Bravus (Carmichael)

Advice to the Queensland Department of Environment and Science

Final report

28 April 2023

Figure 1 Simulated flux at Joshua Spring and at other springs in the Doongmabulla Spring Complex. [Figure created by CSIRO]

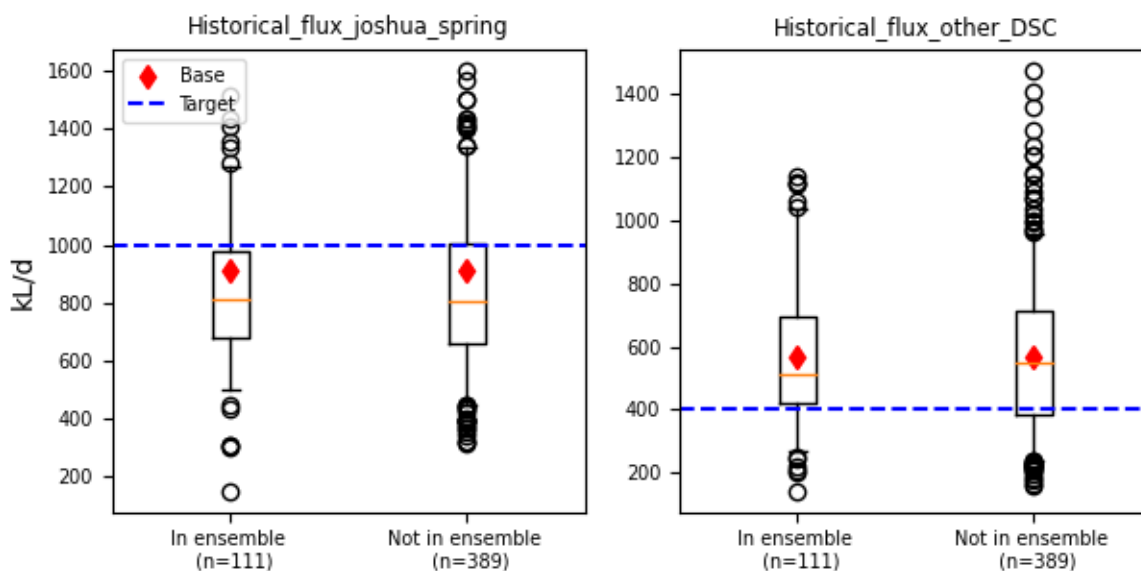
No. The base realisation provides the best fit to the objective function and the parameter combinations retained in the ensemble used for prediction where all meet the predefined objective function thresholds. However, the flux targets, i.e. the estimated spring flow from field data at Joshua Spring and other Doongmabulla springs Figure 1, are not used to constrain the predictive ensemble. The groundwater model report [3] mentions that springflow estimates are not used as acceptance criteria as they are more uncertain. While this is correct, it leads to the inclusion of parameter combinations in the predictive ensemble that result in springflow estimates that are more than twice as large as those estimated for the other Doongmabulla springs and less than half of what is estimated for Joshua Spring.

The scatterplots of observed to simulated values (Figure 4.12 on p 86 and Figure 4.13 on p 87 in the groundwater model report [3]) and the hydrographs (Appendix C of [3]) identify many areas with large systematic deviations from the observed values. Of particular concern is the systematic overestimation of groundwater levels in the vicinity of the Carmichael River and the Doongmabulla Spring Complex. This

results in the model predominantly predicting groundwater inflows to the river or a gaining system, instead of a losing system as reported in the Hydrogeological Conceptual Model report [2]. This compromises the ability of the model to simulate any drawdown at these receptors and is discussed in detail in 2.1.5.

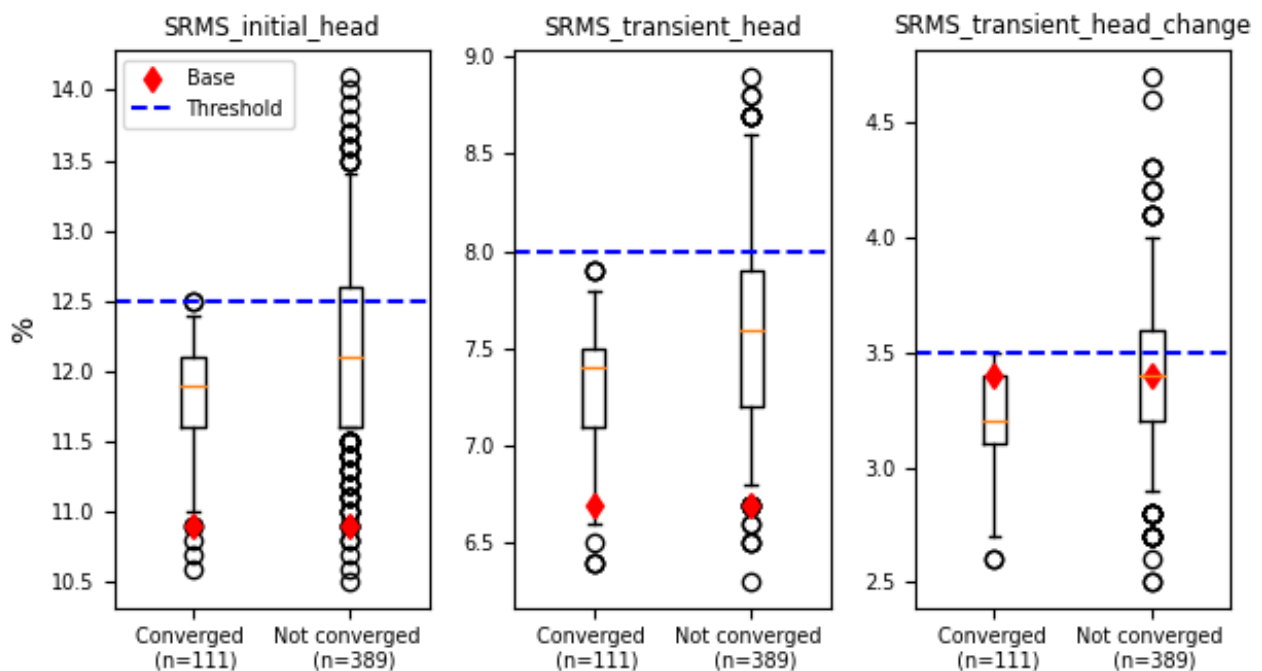
Out of 500 model realisations, including the base case, 7 failed to converge in steady state, 231 converged in steady state but failed to meet acceptance thresholds for history matching, and 157 failed to converge in the post-mining predictive scenario. The predictive ensemble includes 105 parameter combinations, or 21% of the 500 possible realisations. There are no impact predictions for the 395 parameter combinations, or 79% of the 500 possible realisations, that failed to converge or to meet the acceptance thresholds.

Figure 2 shows the summary statistics for the converged and not converged parameter combinations. While the median values for the summary statistics for non-converging parameter combinations are higher

Recommendation: Identify, document, and address the reasons why the model fails to converge to provide confidence that the model provides an acceptable/realistic range of potential impacts.

Figure 3 Comparison of difference between average and median values (m) and natural fluctuations (m) and over the baseline period for monitoring bores in the alluvium and Joe Joe Group

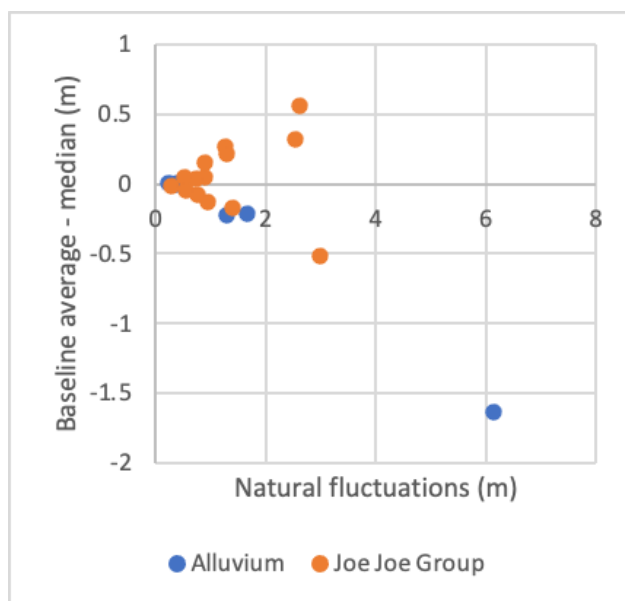
Groundwater level thresholds assume baseline groundwater level fluctuations are normally distributed, subtracting 50% of natural fluctuations in groundwater levels (the median value) from the average groundwater levels measured during the baseline period. However, groundwater levels in monitoring bores over the baseline period are not normally distributed. Figure 3 shows the method systematically under- or over- estimates natural fluctuations, where negative values indicate the average is less than the median (50% NF) using monitoring bores in the alluvium and Joe Joe Group as an example.

The rules used to calculate the groundwater level thresholds appear to be consistent with those documented in the GMMP (Table 45 on p 258 of Adani Mining Pty Ltd, 2021). Table A.1 contains errors in reported values for bore C14028SP in the alluvium (p 49 in Appendix A of the GMMP Review report [1]). Only alluvium and Joe Joe Group values were reviewed for this report.

- duration of the baseline monitoring period is very short (2 years) with respect to climate patterns and climate change, as noted in previous reviews (Appendix F of the GMMP Review report [1]). To use an extended baseline period may also potentially assume climatic stationarity. A moving average for the minimum and maximum values in natural fluctuations may be a more robust approximation but is then determined by the moving average window length. Further consideration is warranted to establish a viable precautionary approach.

Figure 5 Regional scale mapping from the Integrating BA model report (p 4, Southern Highlands Structural Geology, 2022) showing range of mapping scales used to develop the structural geological model

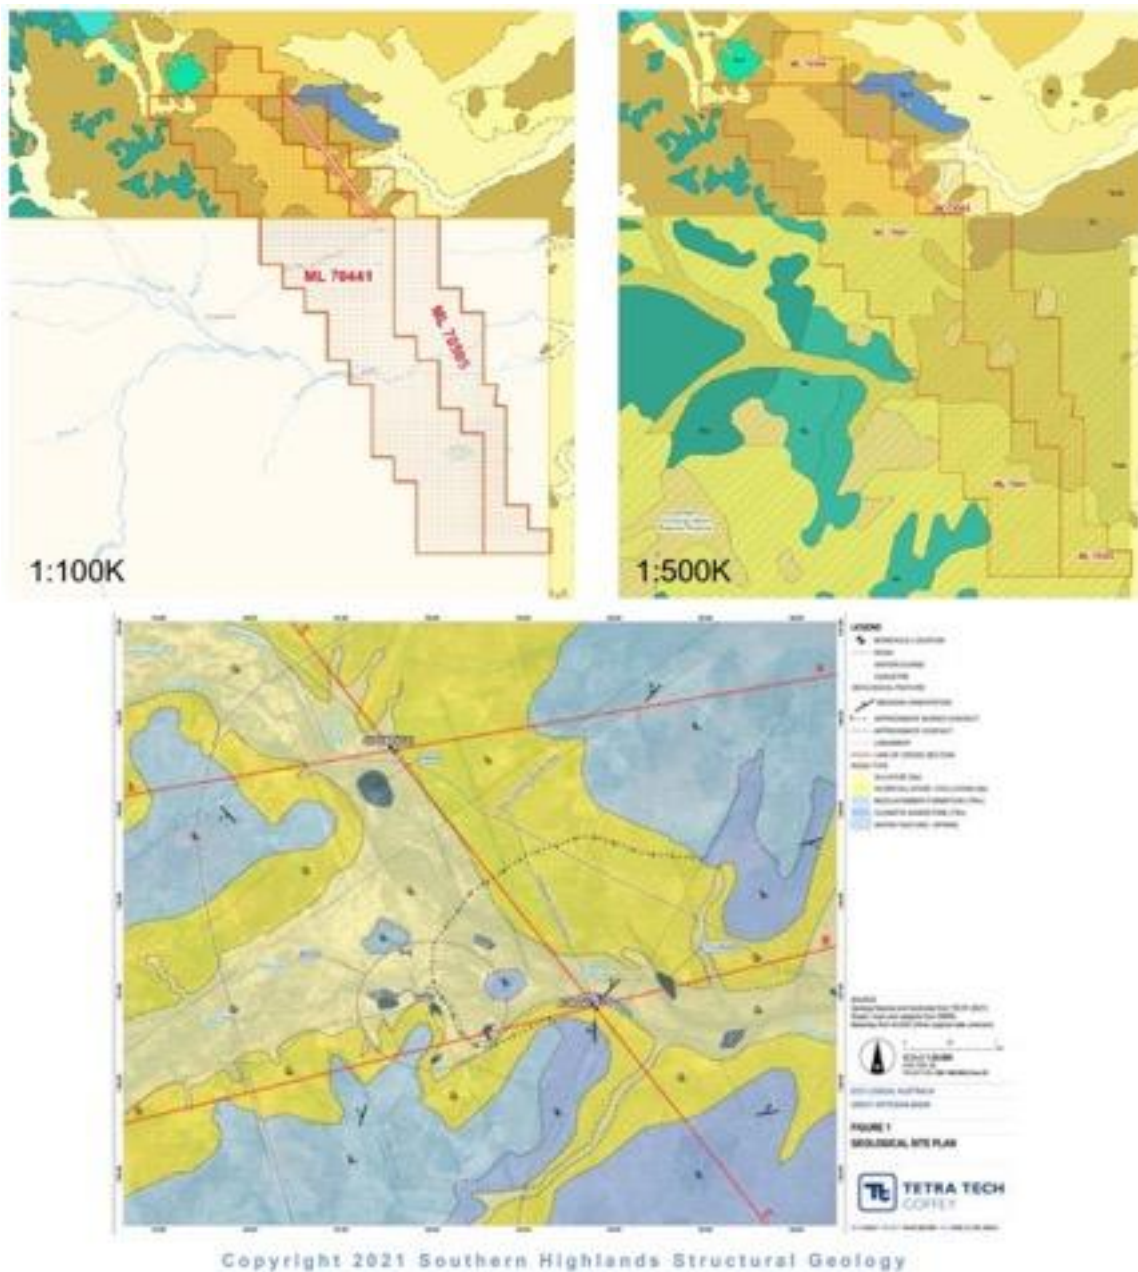
Regional scale mapping across a range of scales is used to develop the structural geological model underpinning the groundwater model. Consistent 1:100 k mapping coverage is now available for all of Queensland, including the Carmichael Coal Mine area. The Bioregional Assessment and structural surfaces in the 'Integrating Bioregional Assessment model' report by Southern Highlands Structural Geology (2022) (Figure 5) pre-date this new dataset.

Depending on which regional surface geological model is used (1:250k, 1:100k), the boundary between the Clematis-Dunda beds can shift by approximately 2 km in the vicinity of Doongmabulla Springs and Surprise Creek. For example, the largest values of predicted maximum drawdown for the open-cut only scenario in the Clematis Sandstone occurs where this layer is mapped within the mine lease area to the south of the Carmichael River (Figure 3.7 on p 26 of the groundwater model report [3]). Any change in the mapped extent of the Clematis Sandstone in this area will directly affect predicted drawdown in the Clematis Sandstone.

Modelled outcrop extents represented in the updated groundwater model (Figure 3.25 on p 59 of the groundwater model report [3]) have changed significantly from the SEIS Hydrogeology report (Figure 30 on p 95 of GHD, 2013) for the alluvium, Tertiary/Weathering Zone and Moolayember Formation. The Hydrogeological Conceptual Model report [2] cites the fault mapping and modelling report (2021) as the source of the new geological model. However, the maximum extent shown in Figure 35 on p 52 of the fault mapping and modelling report (2021) is inconsistent with the modelled extent of these layers. The changes in the geological model outside this extent are not explained in the conceptualisation report and it is unclear what work has informed these changes.

Recommendation: Identify, document, and update groundwater model layer extents and model parameters using updated 1:100 k geological mapping for Queensland.
